# UNITED STATES PATENT AND TRADEMARK OFFICE

### Office Action Summary

10/568,812

**DETAILED ACTION**

**Fig. 3**

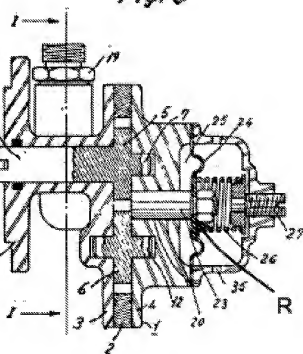
6. Nevertheless, Zenith, with reference to figure 3 below, describes a fluid pump with a pressure chamber (25) wherein the pressure prevailing in the pressure chamber (25) influences the force on the valve piston (23) in the closing direction in such a way that as the pressure in the pressure chamber (25) decreases, the force on the valve piston (23) in the closing direction increases. The advantage of this pressure chamber, as described by Zenith on page 1, line 34 is to "provide in a pump of this type an exact regulation of the pump delivery pressure".

10. In re claim 11, with reference to figure 3 above, Zenith discloses the pressure chamber (25) delimited by a moving wall (24), one side of which is acted on by the pressure prevailing in the pressure chamber (25) and the other side of which is acted on by a prestressed spring (26) that pushes the wall (24) toward the valve piston (23) in its closing direction.

11. In re claim 12, Zenith discloses the moving wall (24) supported against the valve piston (23) by means of a rod (R).

12. In re claims 13-14, with reference to figure 3 above, Zenith discloses the moving wall (24) is embodied in the form of a diaphragm.

13. In re claims 15-18, with reference to figures 2 and 3, Zenith discloses the valve piston (23) at least partially delimiting the pump chamber (13) in the direction of the rotation axis of the

at least one delivery element (5, 6), wherein the closing spring (26) presses the valve piston (23) against the end surface of the at least one delivery element (5, 6) oriented toward it, which end surface functions as a valve seat, and wherein the pressure prevailing in the pressure chamber (25) acts on at least part of the end surface of the valve piston (23) oriented toward the at least one delivery element (5, 6).
